**BASIN ELECTRIC
POWER COOPERATIVE**

Re: Basin Electric Power Cooperative
AVS –Neset 345-kV Project
PU-11-696 Application Amendment

Basin Electric Power Cooperative (Basin Electric) is proposing an amendment to the Application for a Consolidated Certificate of Corridor Compatibility (Corridor Certificate) and Route Permit for the AVS-Neset 345-kV Transmission Project (PU-11-696). The following sections describe the route alignment change, as well as any differences this creates from the original Application and subsequent amendments.

AVS-NESET 345kV TRANSMISSION LINE
CASE #PU-11-696

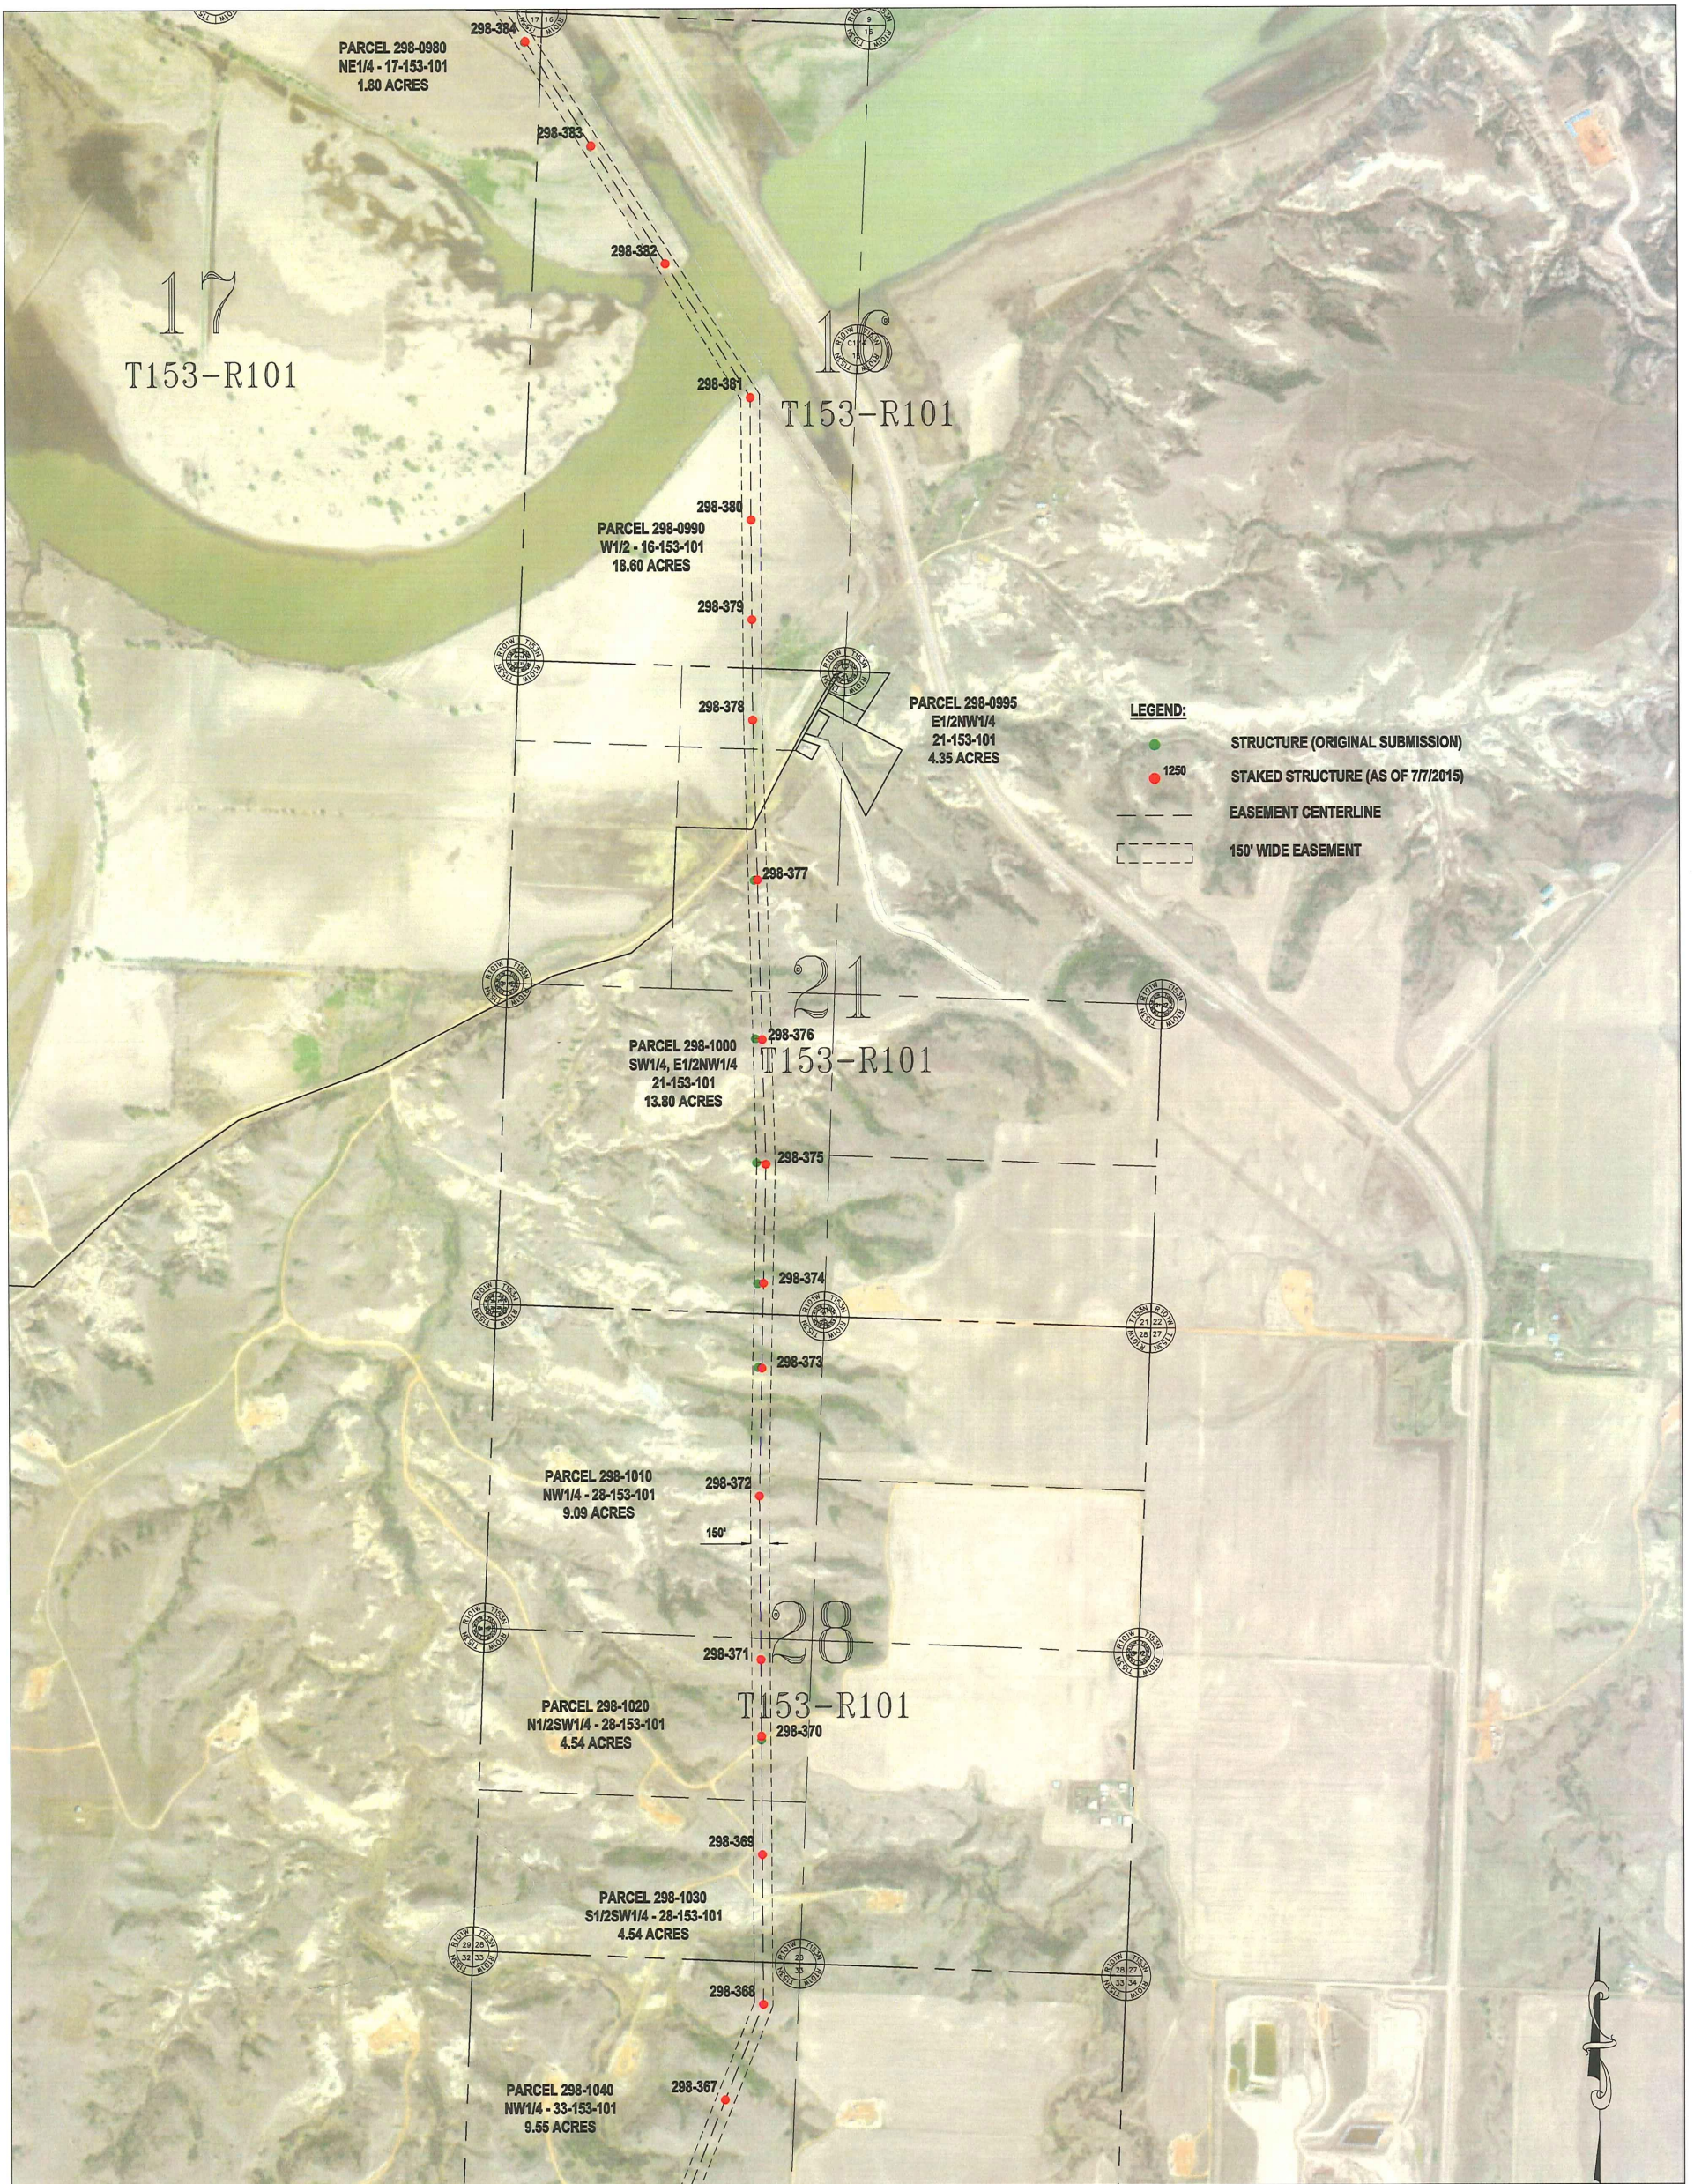
Following submittal of the March 2013 Application for the Project, and during the course of normal transmission line design, Basin Electric identified adjustments to the project alignment. Amendments to the March 2013 Application were submitted, the most recent Amendment submitted in December 2014. Since the December 2014 Amendment, Basin Electric has identified an additional alignment revision. This revision to the previous alignment results from the relocation of a structure, for constructability reasons, approximately 75 feet east of the previous location and generally perpendicular to the right-of-way. This structure adjustment was determined necessary due to the topography of the area and constructability concerns with the steep relief present at the structure location. The structure was adjusted so that the area of high

relief would no longer be a concern in the construction process. This 75-foot required relocation (See Attached Structure Location Drawing) resulted in slight adjustments to the location of four additional structures. Overall, the revised alignment increased less than 10 feet in overall line length (Figure 1 in the attachments).

Basin Electric Power Cooperative
Antelope Valley Station to Neset
345-kV Transmission Project
Route Change Map

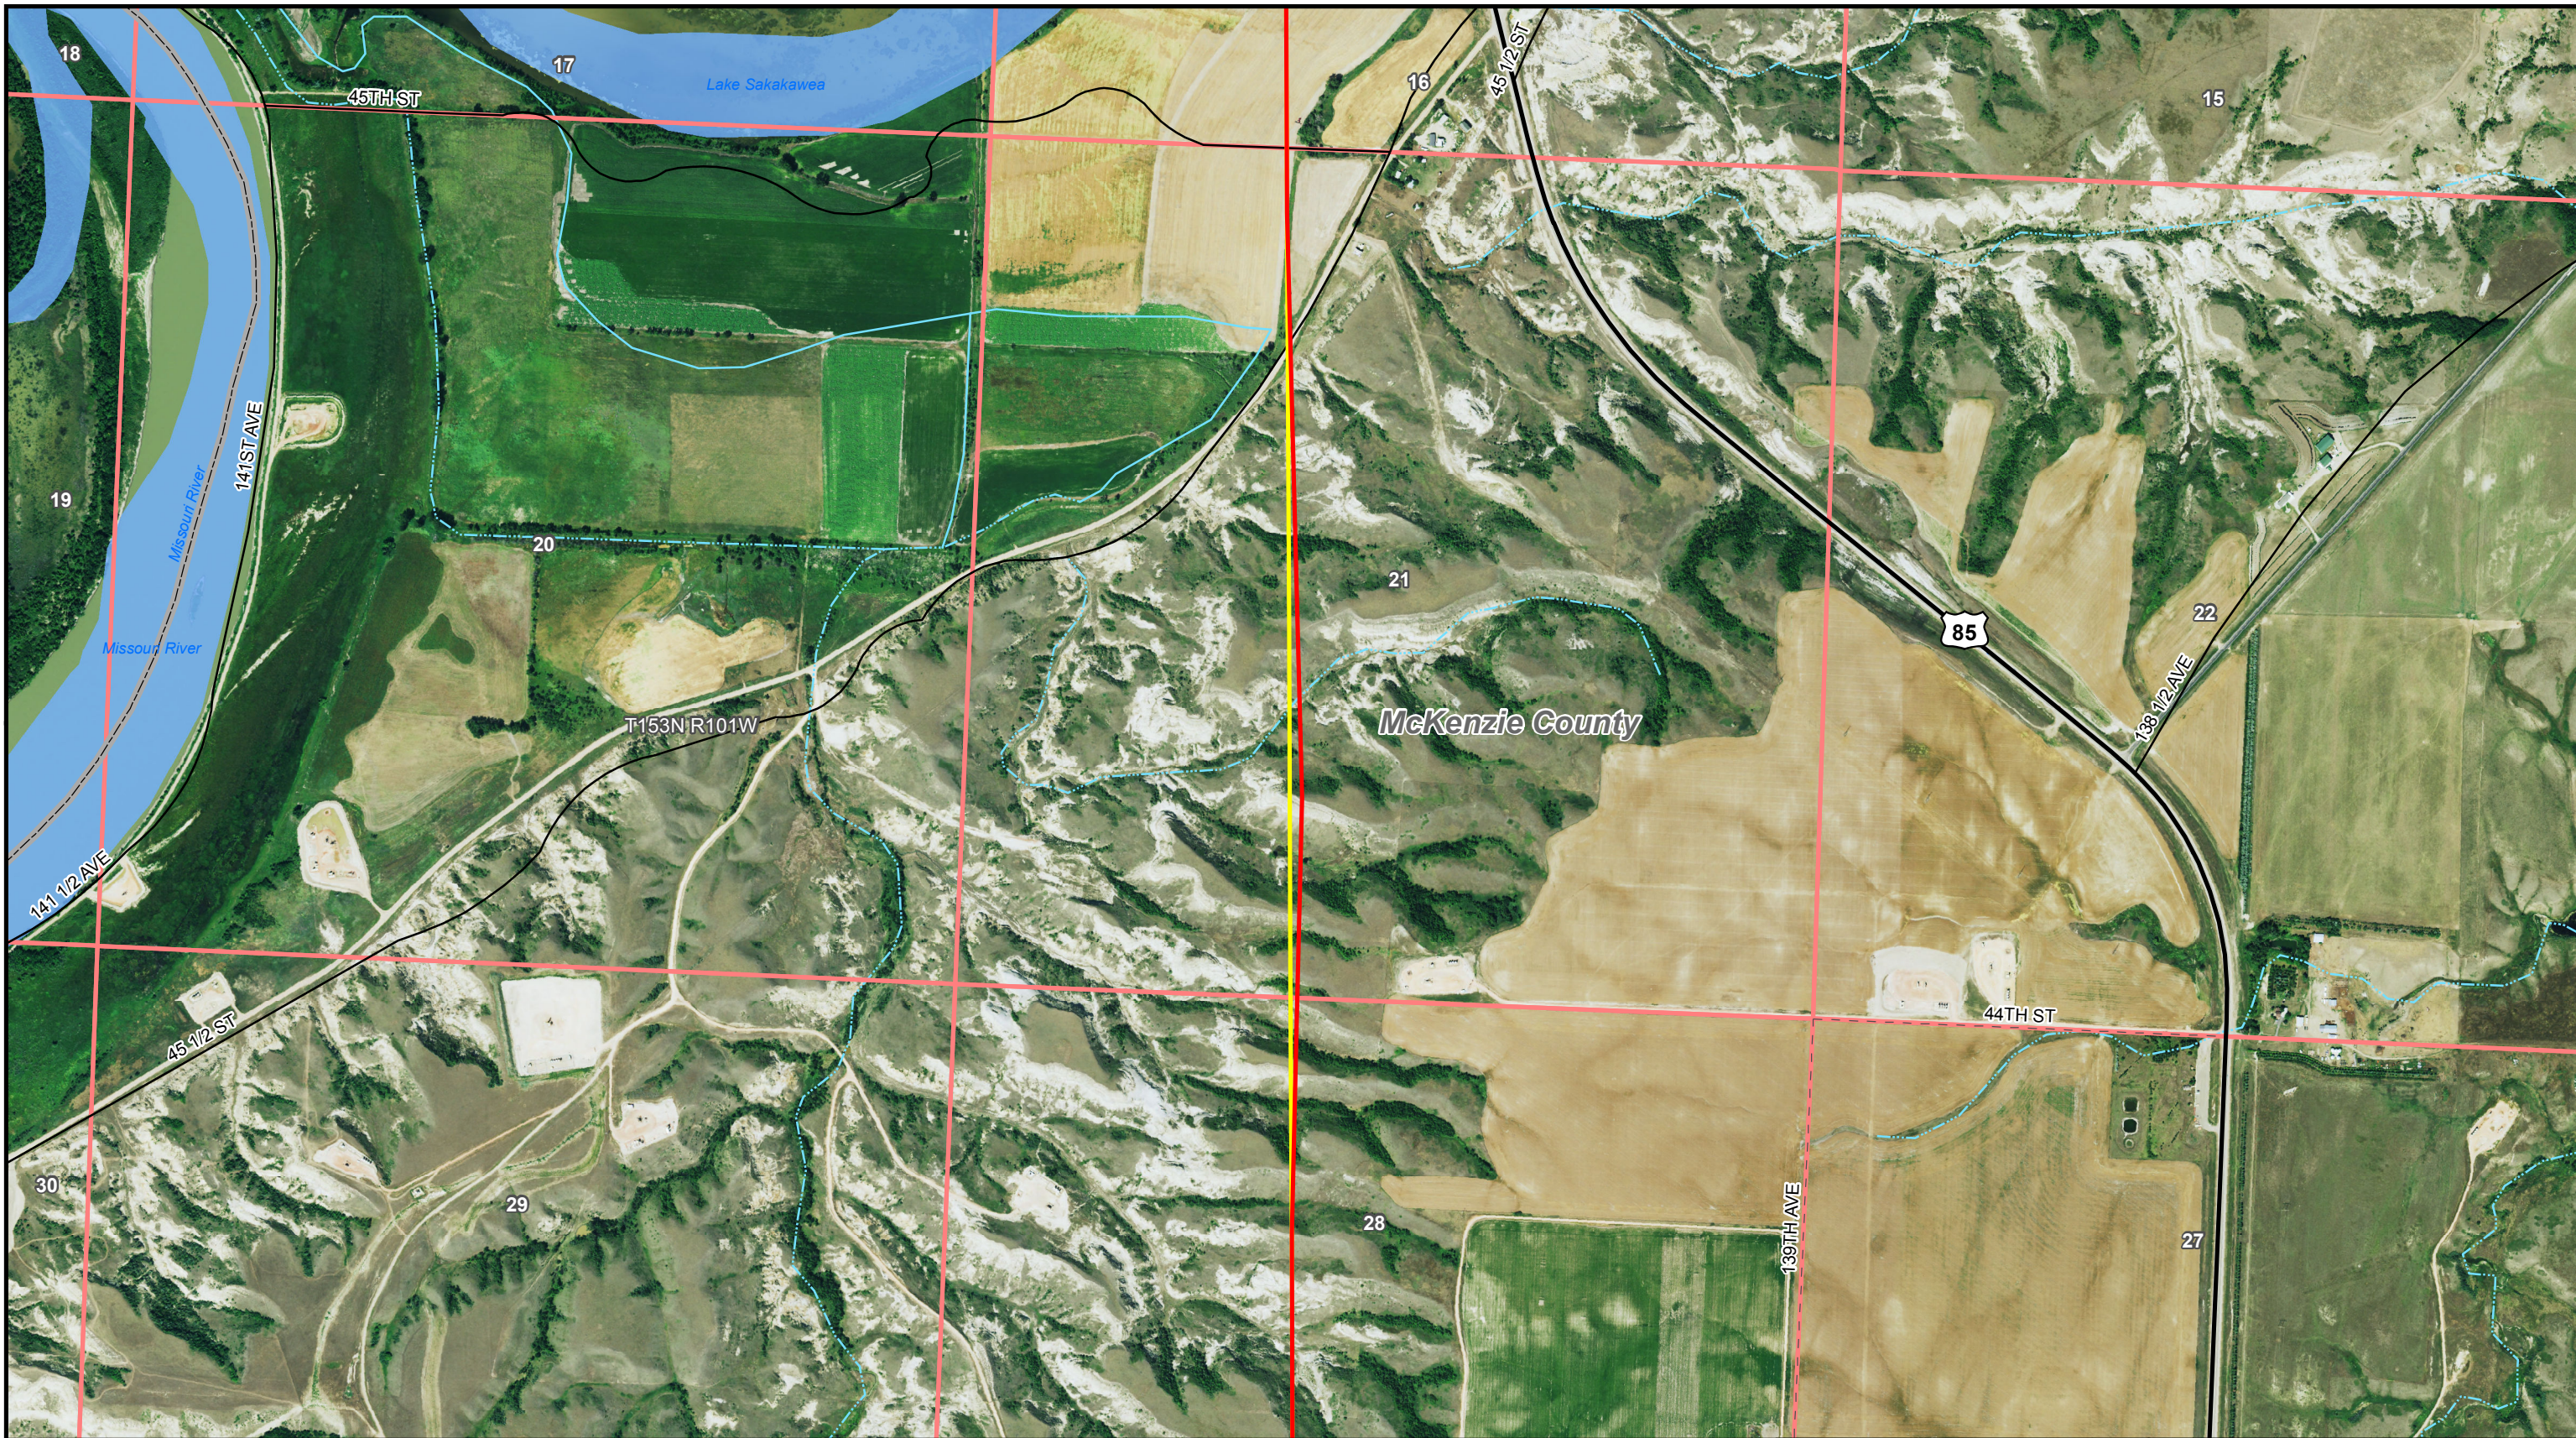
The route revision extends through portions of Sections: Section 21 and 28 in T153N R101W. If approved by the Commission, the total length of the Project would be less than 10 feet longer than the previous alignment. This Corridor/Route revision does not alter the information presented in the original Application or previous Amendments. The Corridor/Route revision is minor and typical of the progression of a linear project. Only siting criteria information that has changed because of the Corridor/Route revision is presented in this amendment. All other portions of the original Application and all subsequent Amendments remain in effect. Map sheet 20 of the Exclusion and Avoidance and Selection Criteria map sheets provided in the Application have been updated to reflect the new alignment and attached to replace the corresponding sheet 20 of the Exclusion and Avoidance and Selection Criteria maps in the Application. As the adjustment is so minor, it is not visibly discernable on the other figures contained in the Application and subsequent amendment. Therefore, no other revised figures are necessary.

As previously stated, the Corridor/Route revision presented in the Route Change Figure (attached) does not alter the information presented in the original March 2013 Application based on a review of exclusion areas, avoidance criteria, selection criteria, and the factors to be considered in NDCC Section 49-22-09 of the North Dakota Energy Conversion and Transmission Facility Siting Act. The Corridor/Route revisions are minor and typical of the progression of a linear project.
